NUCLEAR REGULATORY COMMISSION

Title: Advisory Committee on Reactor Safeguards
 Regulatory Policies and Practices

Date: Monday, September 16, 2013

- ACRS comments on MACCS2 weather uncertainty integration and convergence of results, and staff responses
- MELCOR parameters of interest
- MACCS2 parameters of interest

MELCOR – MACCS2 – Weather Uncertainty Integration

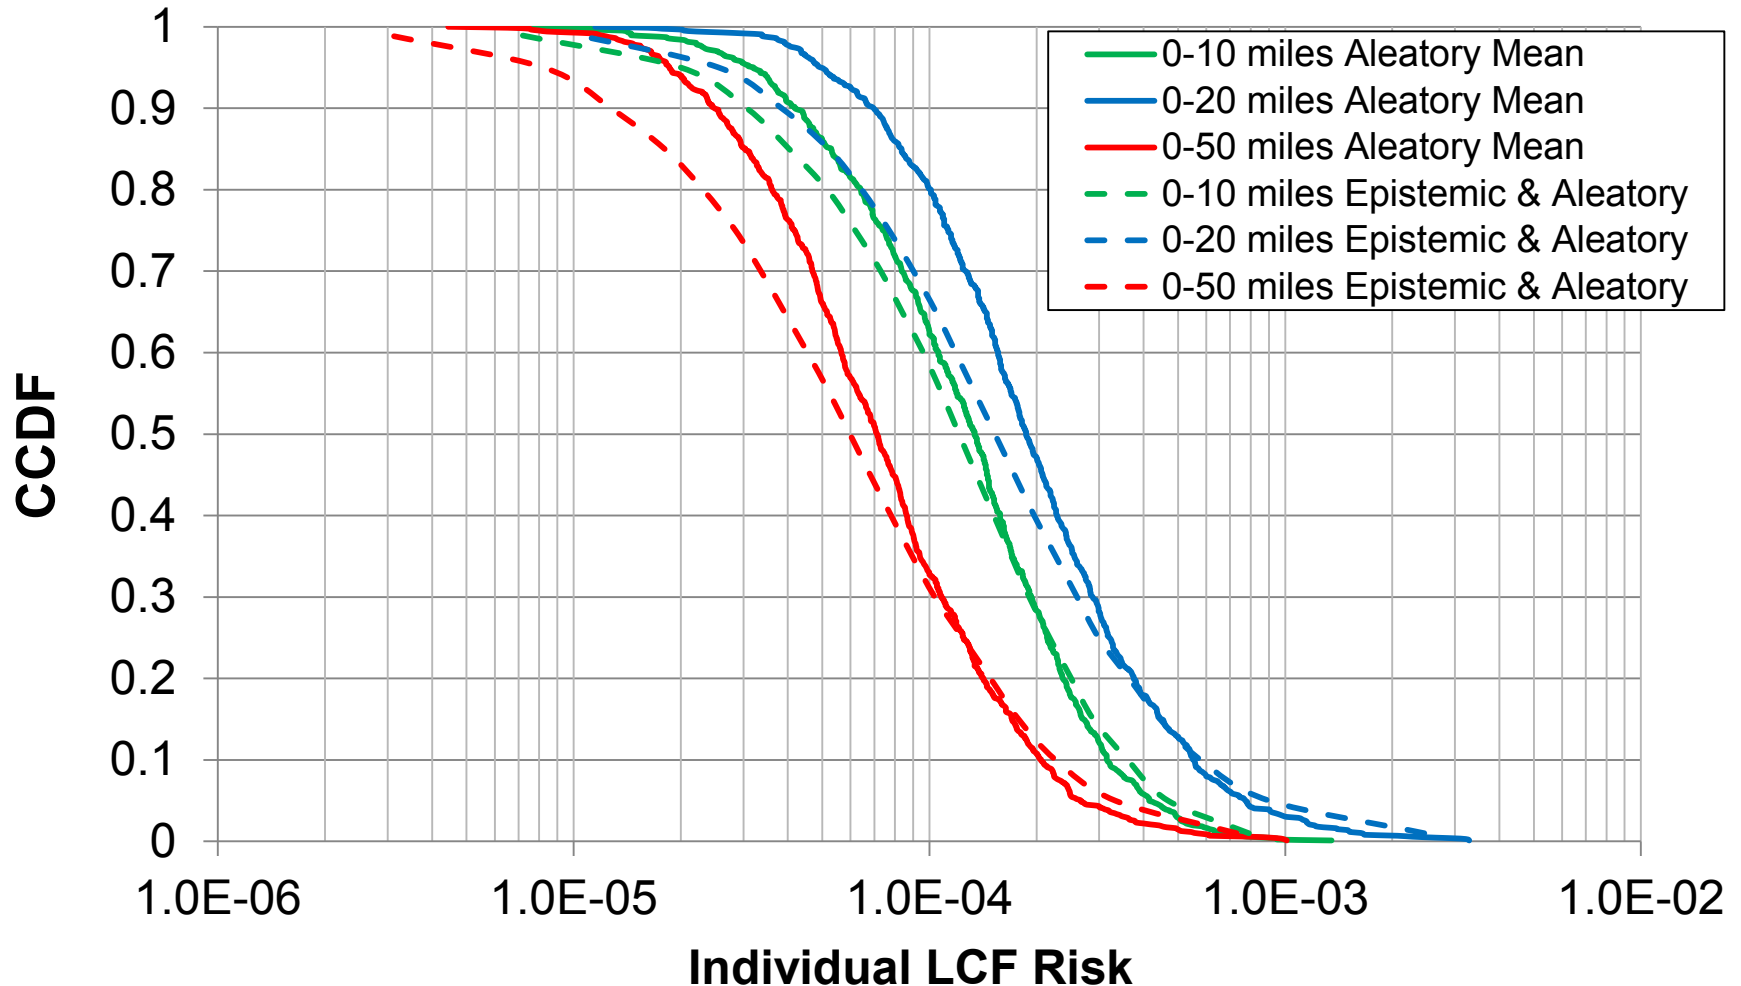
ACRS Comment:

- For the combined MELCOR-MACCS2 results, the report currently presents only results averaged over the weather trials.
- The report should also present results that include and display the full weather aleatory uncertainty

MACCS2 and Weather Uncertainties for LCF Risk 1

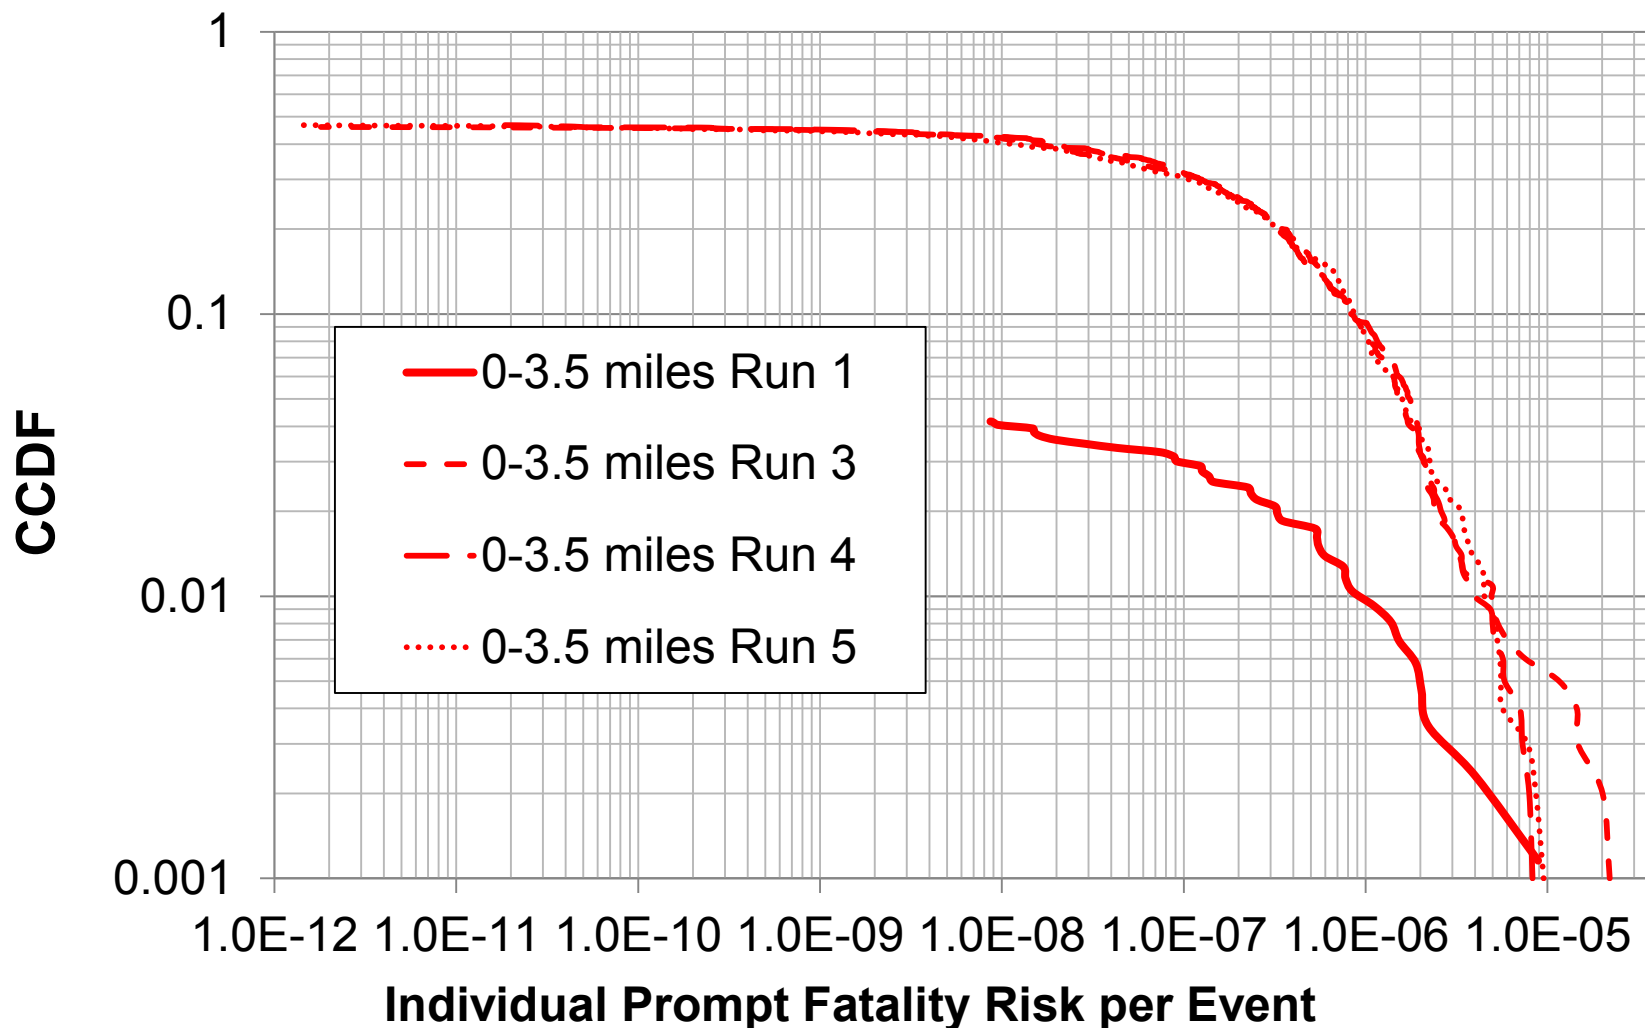
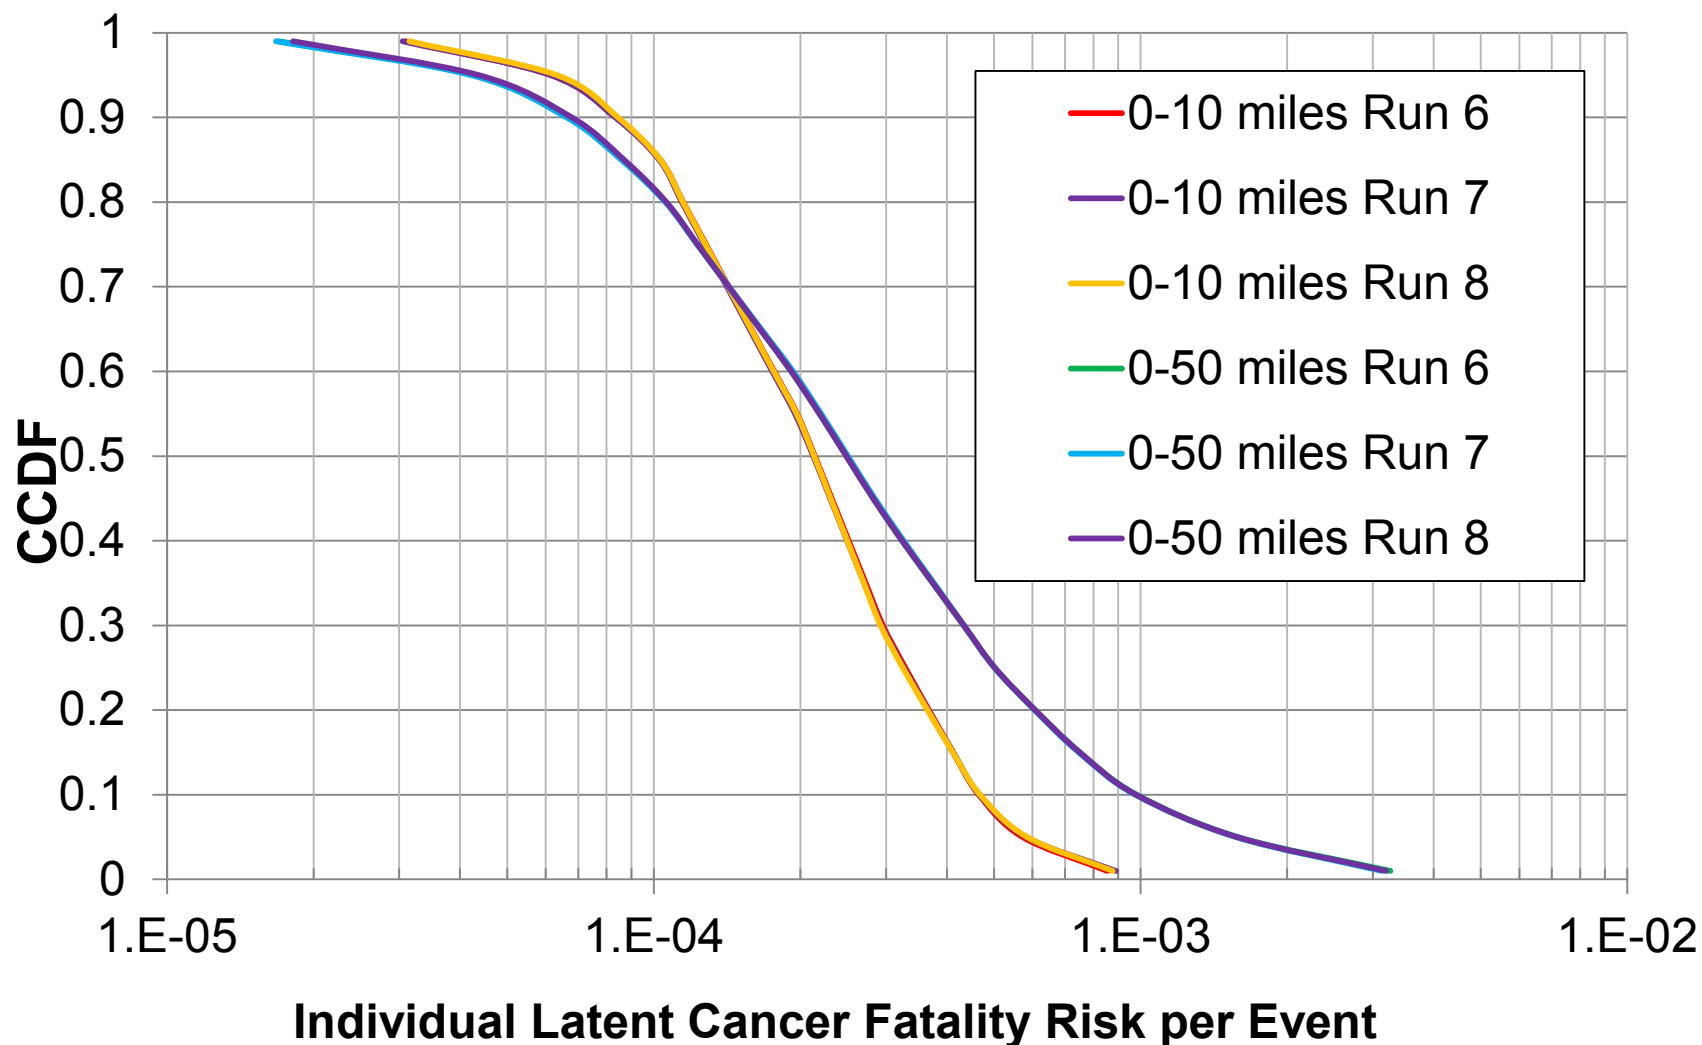
ACRS Comment:

Approach:

- MELCOR Replicate 3, Realization 46 identified as the source term that produced the largest conditional LCF risk consequence
- For that source term, three Monte Carlo runs of sample size 1000 were completed (Runs 6, 7, 8) using three different LHS random seeds for the 350 MACCS2 input parameters
- The same 984 weather trials were used

MACCS2 and Weather Uncertainties for LCF Risk 2

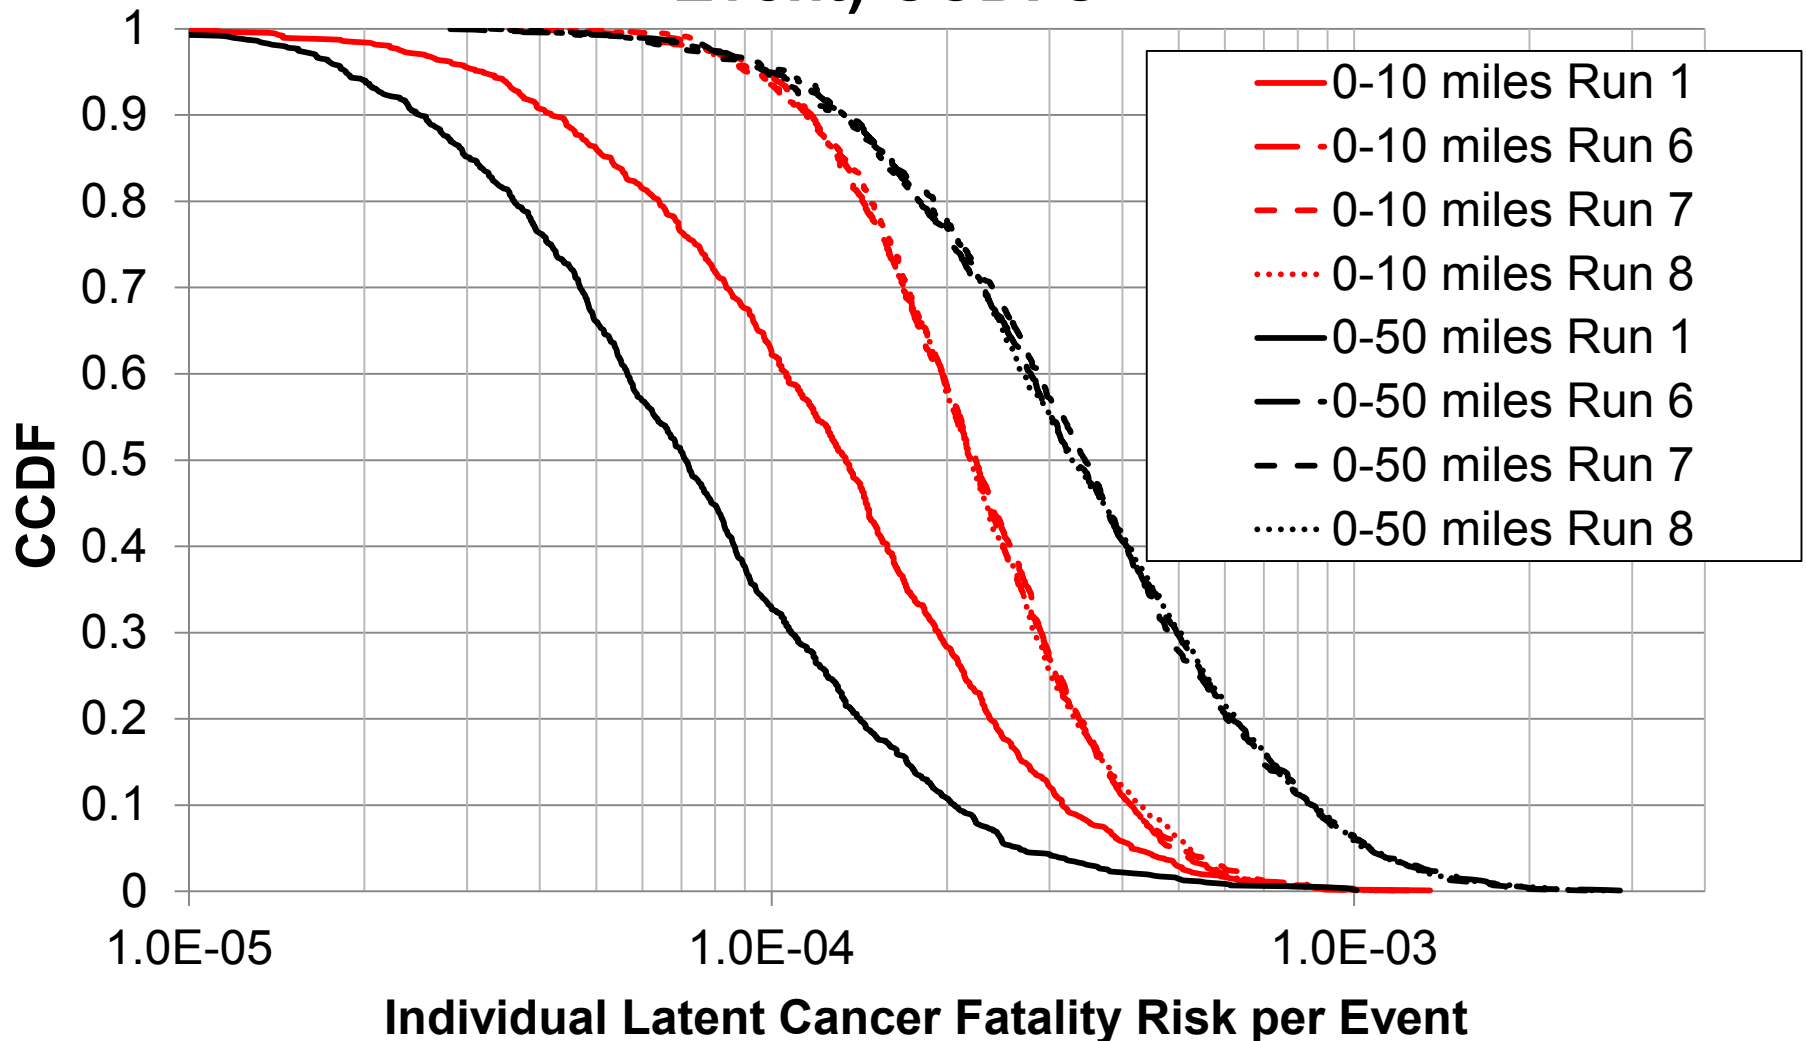
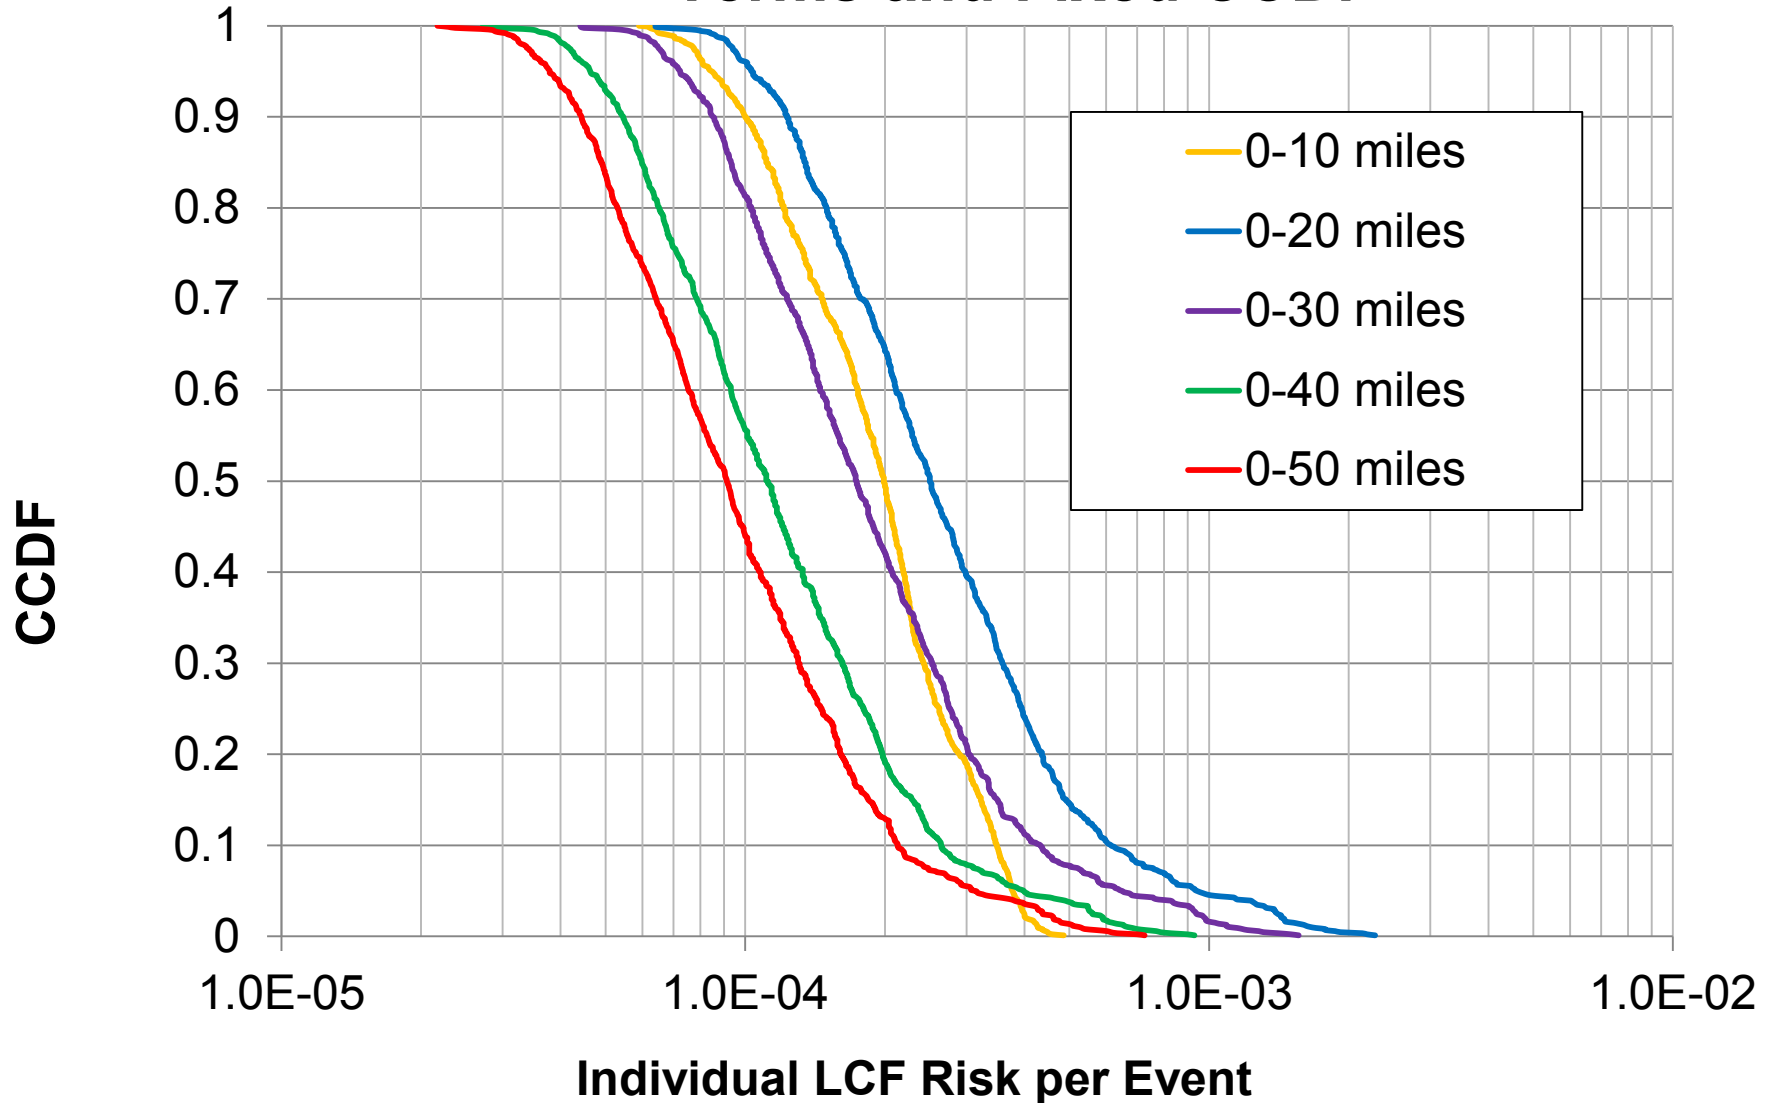
ACRS Comment:

- Select a MELCOR realization that produced a small, but non-zero, contribution to the conditional LCF fatality consequences in the current SOARCA uncertainty results.
- For that realization, sample from the 350 MACCS2 input parameters, and for each epistemic sample generate 984 weather cases to derive an uncertainty distribution for the conditional LCF fatality consequences at each distance.
- Demonstrate convergence of the combined MACCS2-weather uncertainty analysis results.
